Attachment B  
Technical Specification Page Revisions

Consolidated Edison Company of New York, Inc.  
Indian Point Unit No. 2  
Docket No. 50-247  
September 30, 1988

**FIGURE 2.1-1**  
**REACTOR CORE SAFETY LIMIT - FOUR LOOPS IN OPERATION**

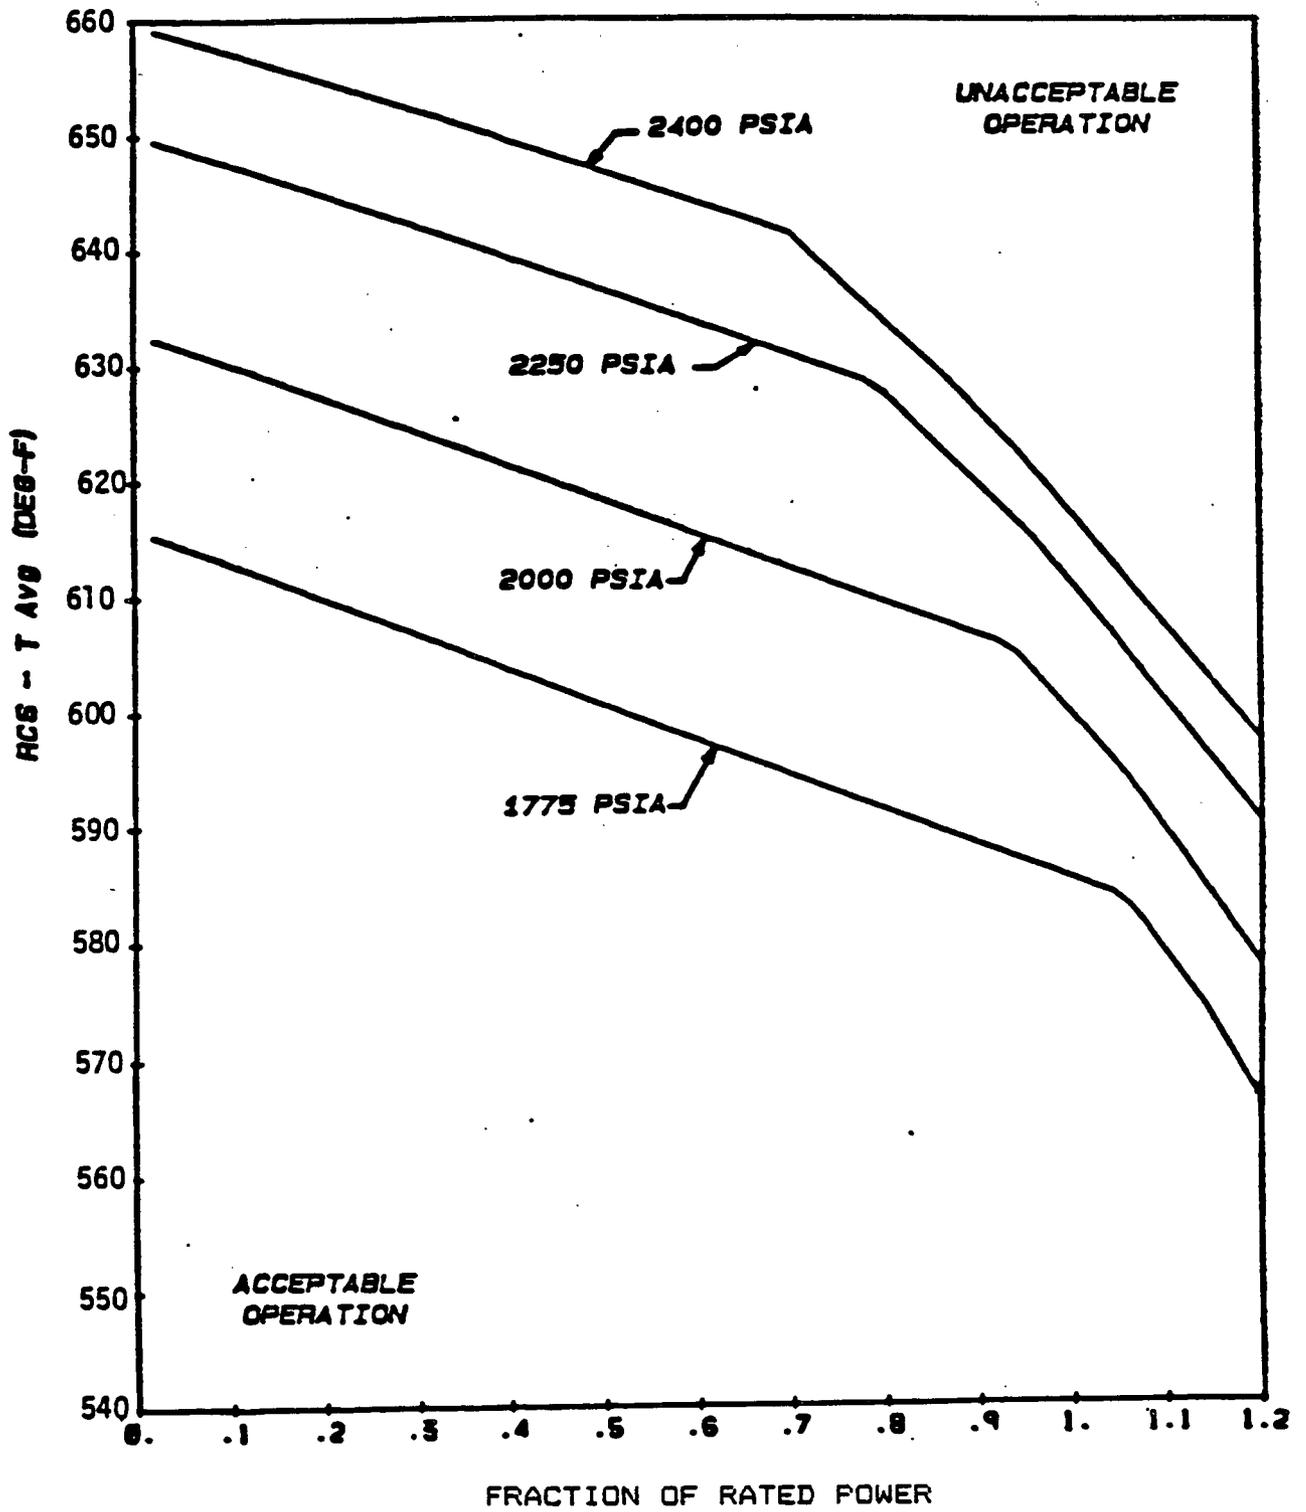
The combination of thermal power level, coolant pressure, and coolant temperature shall not exceed the limits shown in Figures 2.1-1

• The safety limit is exceeded if the point defined by the combination of Reactor Coolant System average temperature and power level is at any time above the appropriate pressure line.

The curves of Figure 2.1-1 show the loci of points of THERMAL POWER Reactor Coolant System pressure and average temperature below which the calculated DNBR is no less than the Safety Limit DNBR value or the average enthalpy at the vessel exit is less than the enthalpy of saturated liquid. These curves are based on a peak nuclear hot channel factor of 1.62 for the LOPAR fuel and a 1.65 for the OFA and a 1.55 cosine axial power shape.

FIGURE 3.10-2  
HOT CHANNEL FACTOR NORMALIZED OPERATING ENVELOPE  
(For S.G. Tube Plugging Levels up to 25%)

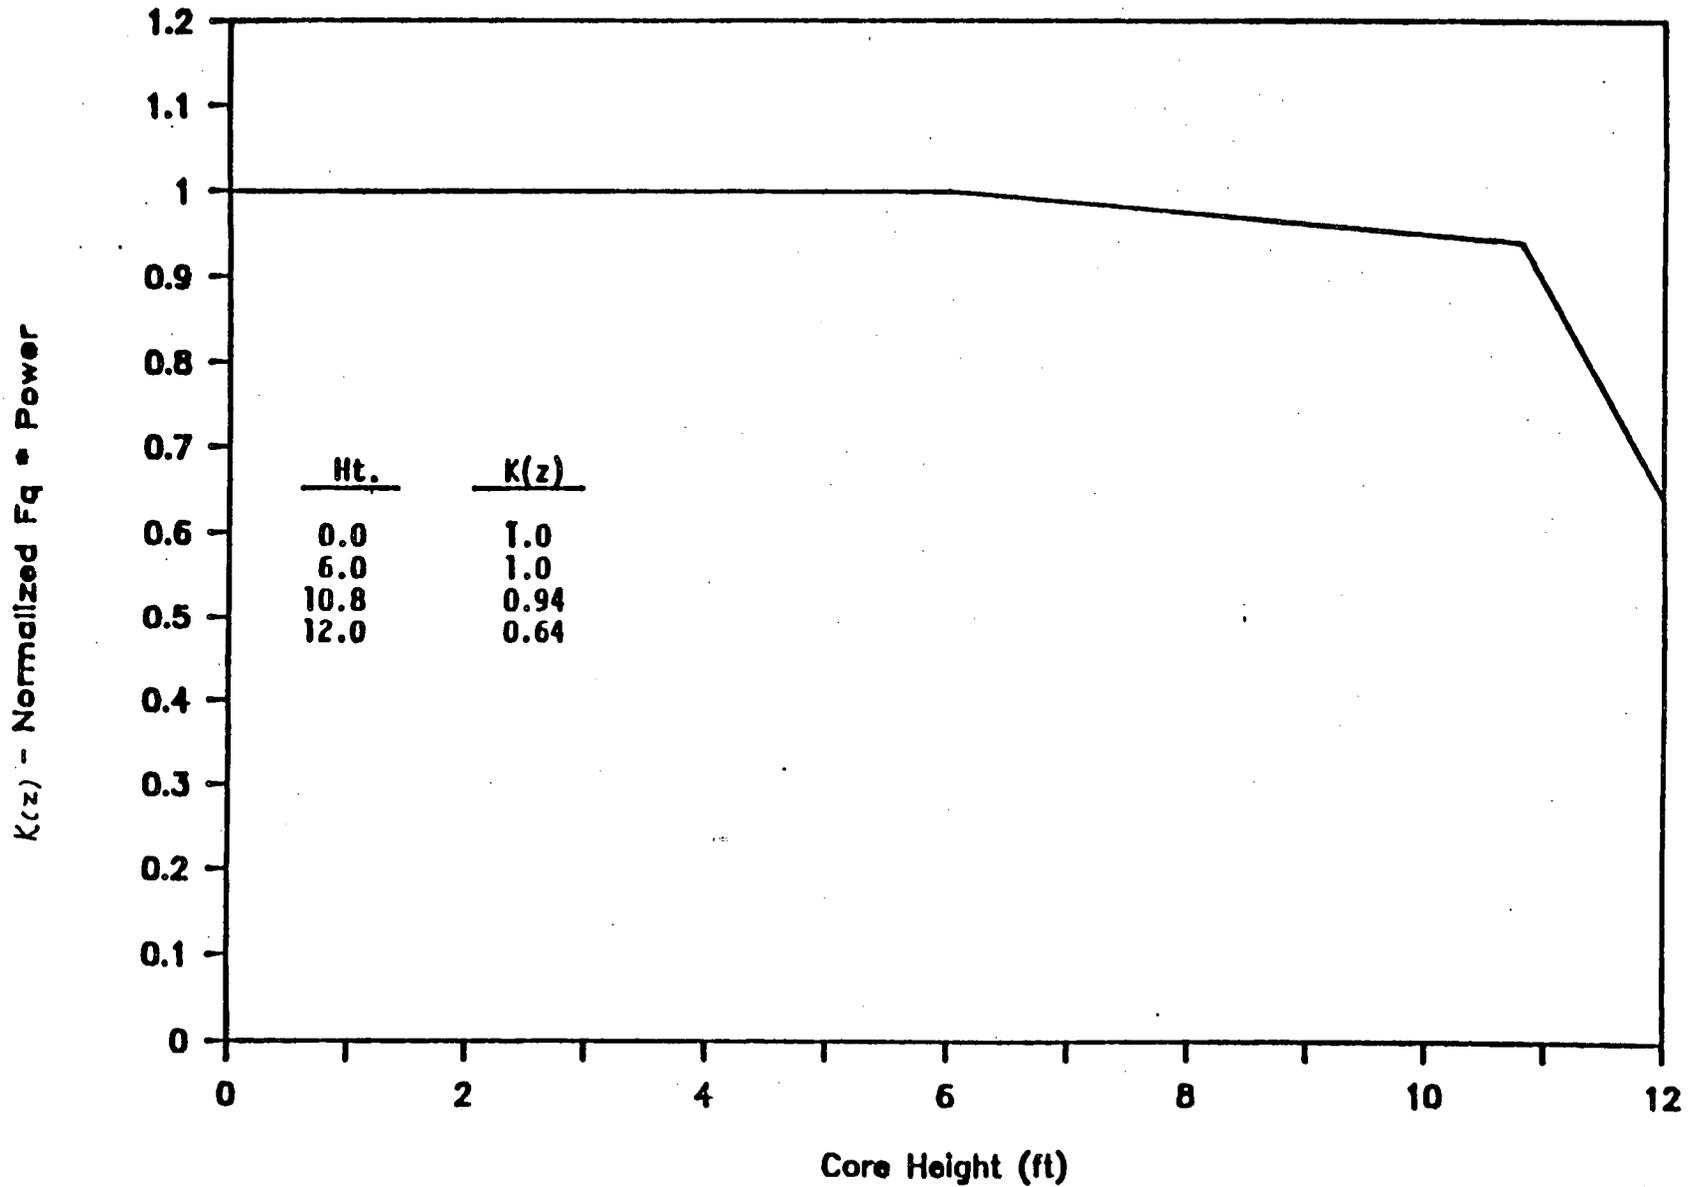
Where P is the fraction of full power at which the core is operating; K(Z) is the fraction given in Figure 3.10-2 and Z is the core height location of  $F_Q$ .

The upper bound envelope of the total peaking factor ( $F_Q$ ) of specification 3.10.2.1 times the normalized peaking factor axial dependence of Figure 3.10-2 has been determined from extensive analyses considering all operating maneuvers consistent with the technical specifications on power distribution control as given in Section 3.10. The results of the loss of coolant accident analyses based on the specified  $F_Q$  times the normalized envelope of Figure 3.10-2 indicate a peak clad temperature of less than 2200°F for the worst case double-ended cold leg guillotine break.<sup>(1)</sup>

Figure 3.10-3

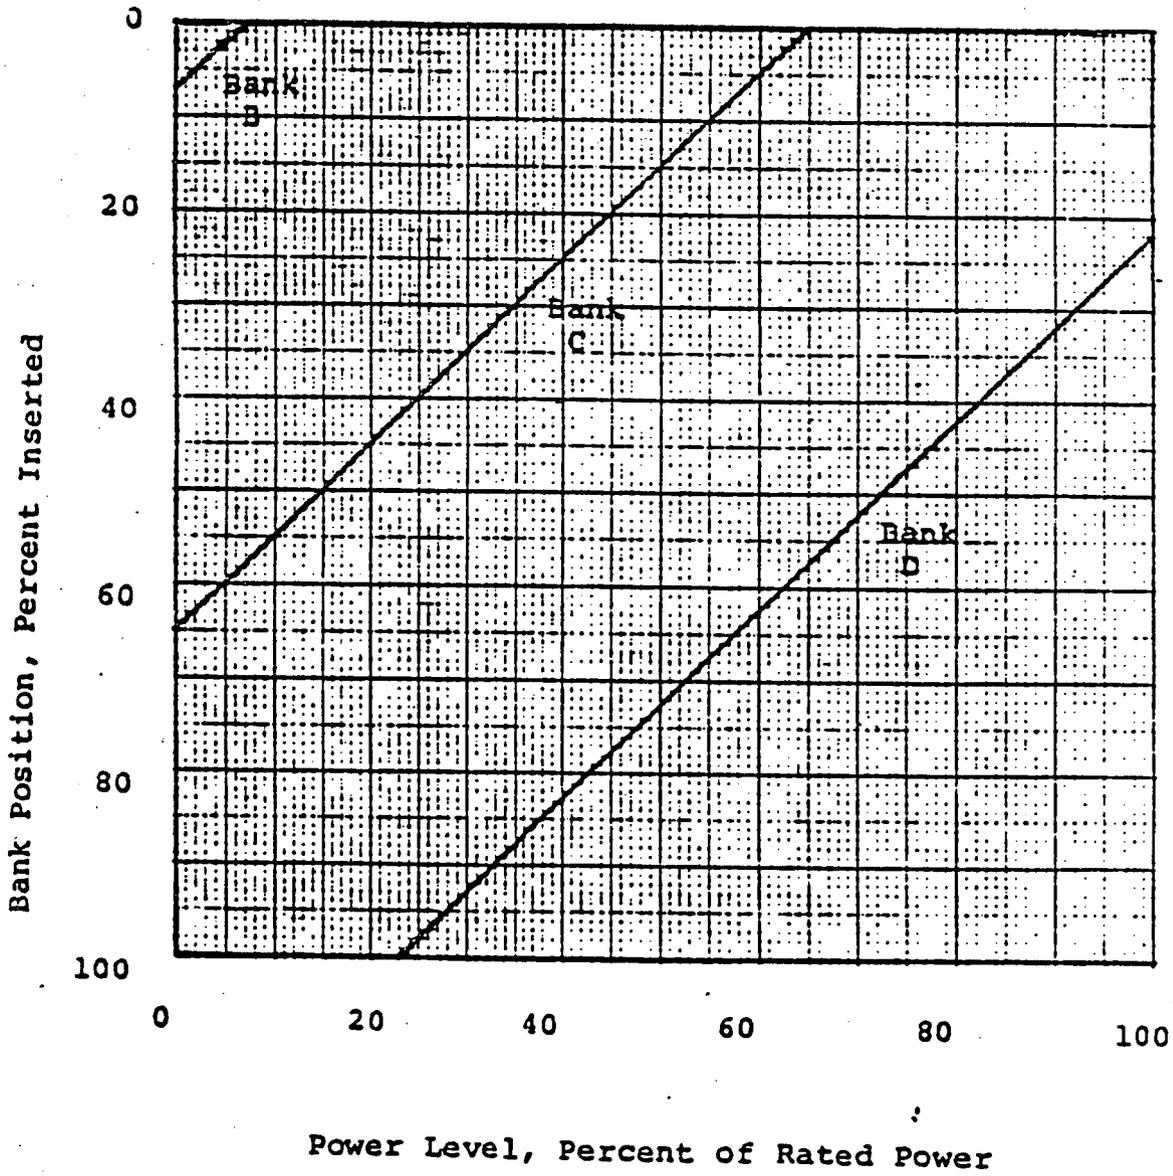
3.10.4.2 When the reactor is critical, the control banks shall be limited in physical insertion to the insertion limits shown in Figure 3.10-3.
